SERVICE BULLETIN

Service Bulletin No.: DAC1-92-07, Rev 1

Title: Operation Limit Changes for EASA
Member Countries

Figure 1 - For Aircraft with the Garmin G500 System Installed

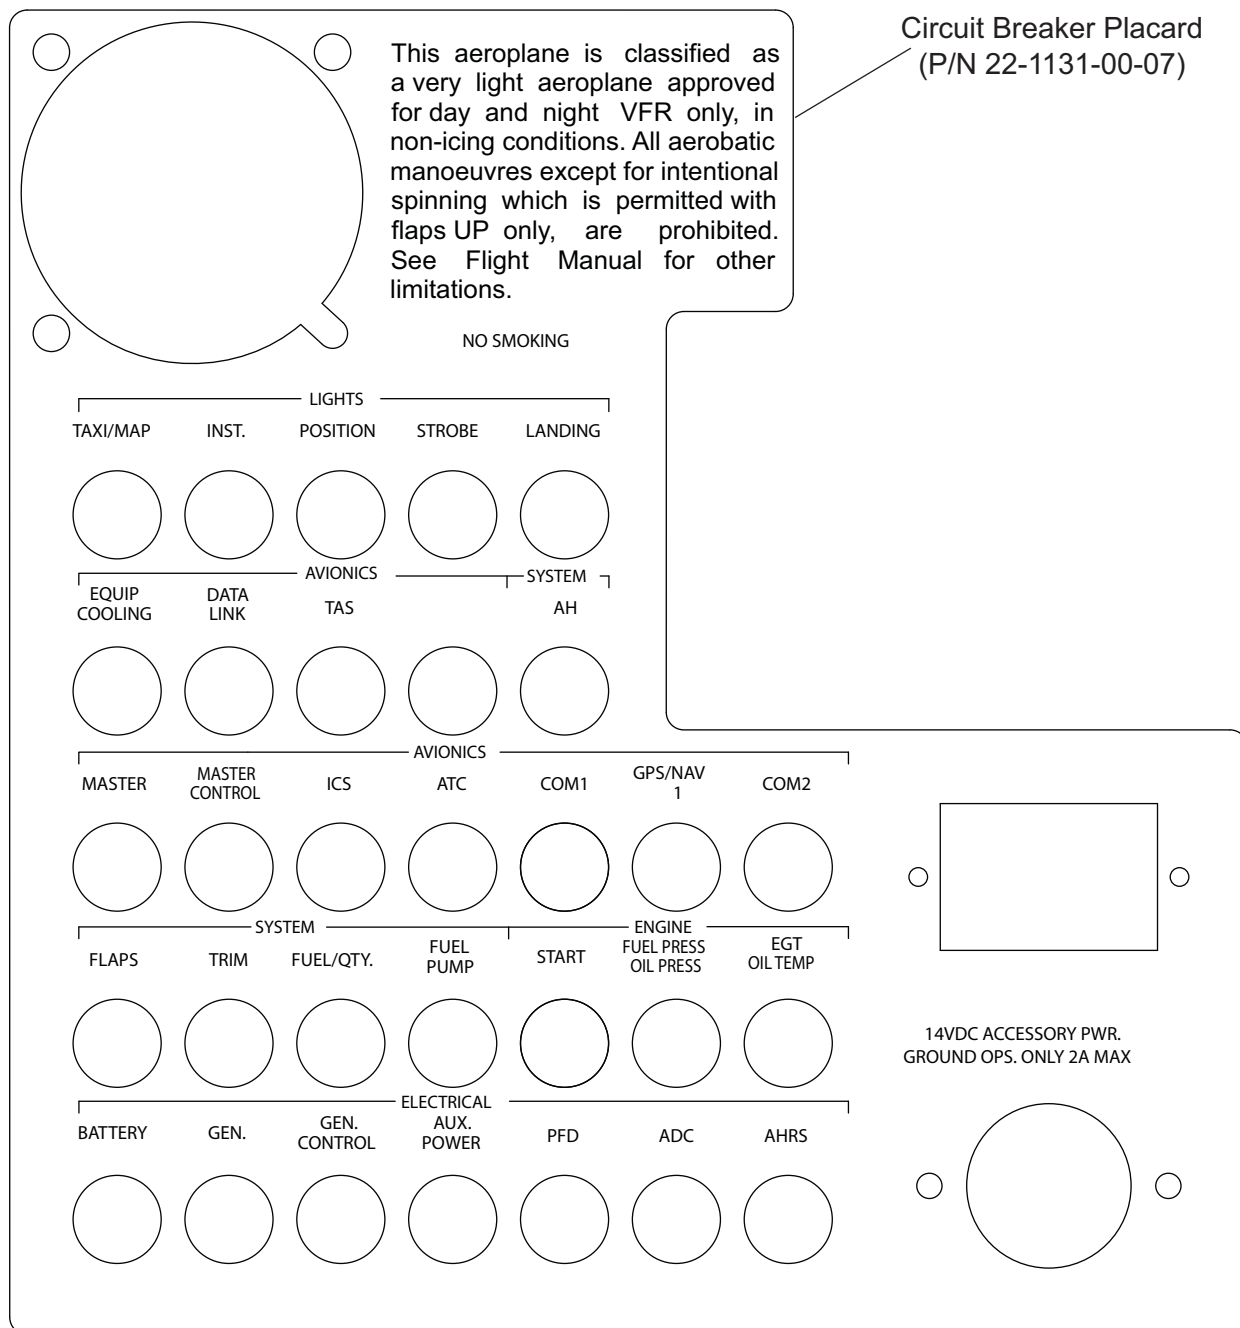
- 10.1 Replace the VLA flight limitations placards as shown in Figures 1 and 2.
- 10.2 Incorporate Revision 26 or later TCCA Approved Revision into the AFM.
- 10.3 On aircraft equipped with the Garmin G500, Backup Artificial Horizon Indicator must be installed. Refer to SB DAC1-34-02, latest approved revision.
- 10.4 On aircraft S/N C0001 thru S/N C0586, illuminated placard must be installed. Refer to SB DAC1-92-08, latest approved revision.

Figure 2 - For Non-Garmin G500 System Equipped Aircraft

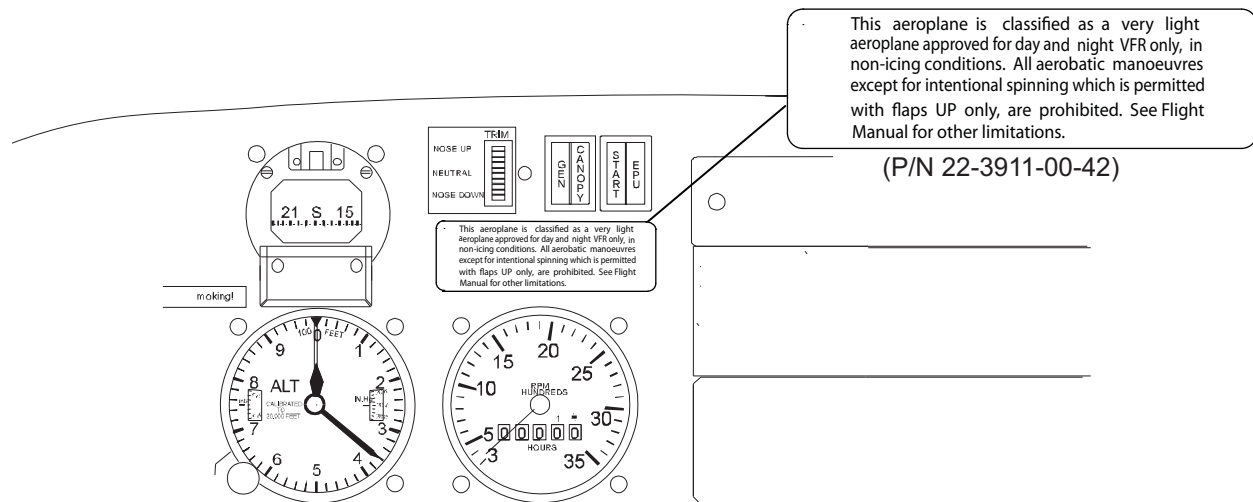
10.6 Replace VLA flight limitations placard as shown in Figure 2 for Non-Garmin G500 system airplanes or as shown in Figure 3 for Garmin G500 system configurations without an artificial horizon indicator.
